NOBLE COMMENT LETTER FOR THE DRAFT AUDIT REPORT FROM THIRD-PARTY AUDITOR – SECOND AUDIT

Third-Party Verification Final Audit Report Second Audit

RE: Noble Energy, Inc. Consent Decree (90-5-2-1-10811) – 1:15-cv-00841 RBJ
Comments to Consent Decree Third-Party Verification Draft Audit Report – Second Audit
SLR Ref: 118.01567.00007

IR Camera Verification Documentation Field Data Sheet

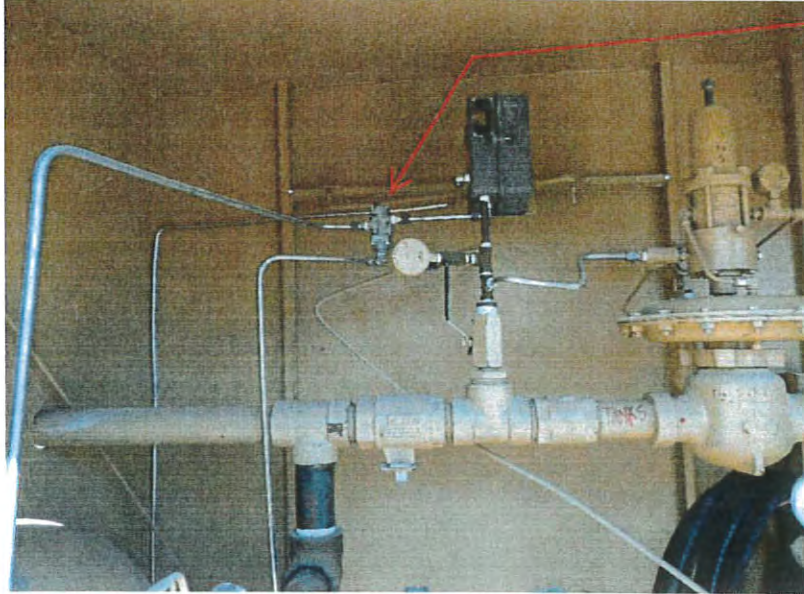
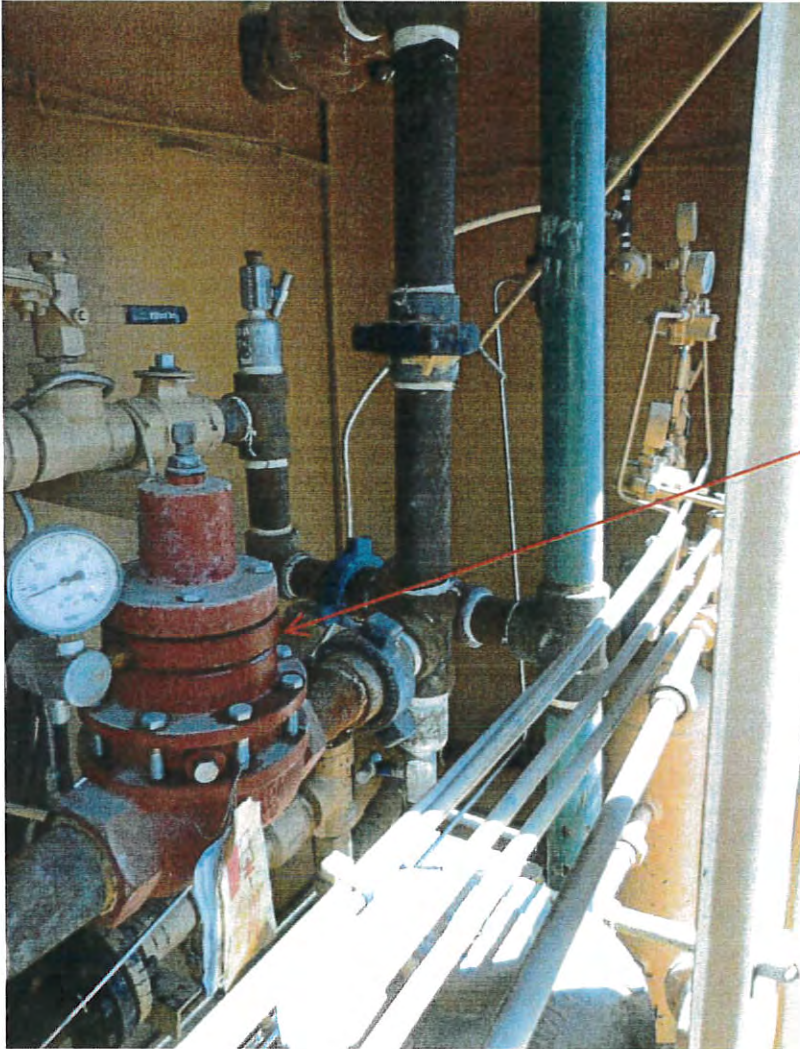
- * IG sense line system has an additional versa valve installed at the LP Fischer controller, it ties in with the Level Switch High High (LSHH) on vessel.
- * Back Pressure line has back pressure valve on each line as well as a common back pressure valve.
- * No Automation has been installed.

Versa valve installed by LP Fischer Controller. Additional line tied into LSHH

Kimray SMT valve as back press high high shown. On P&ID is designated at PCV 103

Each LP separator has a back pressure valve before common LP header.
